PREPARED FOR THE PLAN COMMISSION

Project Address: 208 Cottage Grove Road
Application Type: Demolition Permit and Conditional Use
Legistar File ID # [49922](#)
Prepared By: Timothy M. Parks, Planning Division
Report includes comments from other City agencies, as noted.

Requested Actions: Approval of a demolition permit and conditional uses to demolish a commercial building and construct a four-story mixed-use building with 5,125 square feet of commercial space and 35 apartments, and a separate four-story, 77-unit apartment building at 208 Cottage Grove Road.

Left Image: Current elevation (Sheet a2.2); **Center Image:** Previous version showing required stepback at third floor; **Right Image:** Highlighted floorplan showing encroachment.

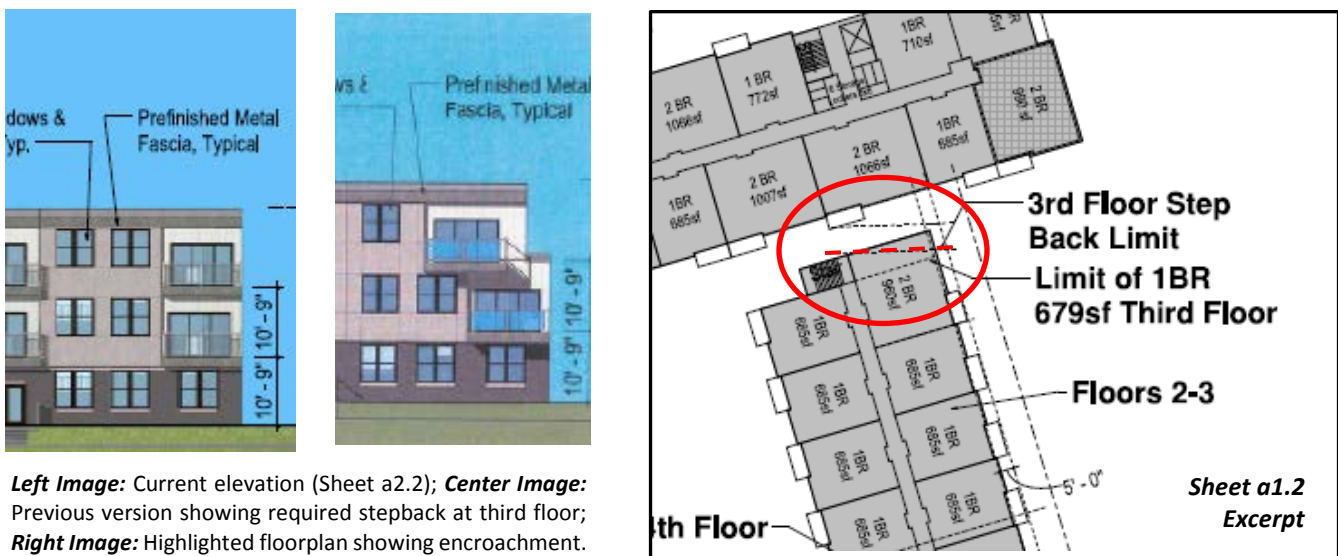
Further, staff believes that the transition from the northeasternmost corner of the building to the north can meet the standards for conditional use approval (standard #12).

The Zoning Administrator has determined that the yard adjacent to Cottage Grove Road is the front yard for the overall project. The rear yard by code is the one most parallel and opposite to the front yard, which is the yard along the northern property line in this case, despite that yard appearing to function like a side yard perpendicular to Johns Street. The building will be set back 22.5 feet from the northern property line. The third floor of the northern building will encroach approximately seven (7) feet into the 45-degree stepback required above two stories at the 20-foot required rear setback. Given the overall setback of the northern building from the residences to the north, staff feels that an appropriate transition is proposed (if the northern property line was considered the side yard, the third floor would meet the transition requirement). The architectural quality of the northern building is also improved with the consistent northern wall plane in staff's opinion compared to an earlier version of the northern building, which appeared to meet the transition requirement but resulted in an awkward transition architecturally along the façade facing Johns Street. The images above illustrate the northeastern corner of the building not providing the transition (left), the same portion of the building with the stepback/transition (center), and the area on the floorplans where the encroachment into the required stepback/transition is depicted for reference (right).

5. Revise the plans to provide a section or detailed elevation confirming the transition of the three-story portion of the northern building to the north, per final Planning Division approval.
